Office Action Summary

10/782,735

COVINO ET AL.

DETAILED ACTION

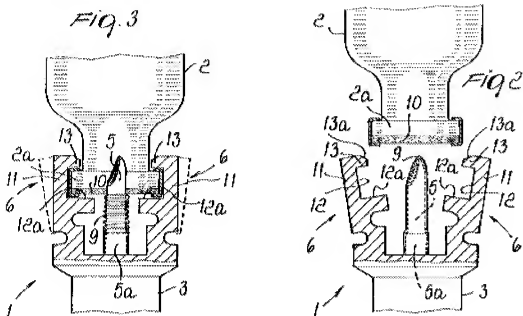
In figures 2 and 3 above, the Azzolini patent shows cams having two tips (12a, 13a) which perpendicularly engage with the thread.

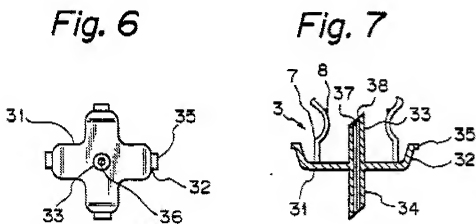
Furthermore, the Uchida patent, in figures 6 and 7 above, shows a design having three points of contact and at least two tips. Figure 7 shows a distal tip (not numbered)

at the distal end of the cam and a second tip (8) located proximally from the distal tip. Notably, the arched shaped of the cam creates four possible point of contact that comprise of (1) contact with the distal tip, (2) contact with the second tip, (3) contact with the arched portion of the cam, and (4) contact with the straight and most proximal portion of the cam.
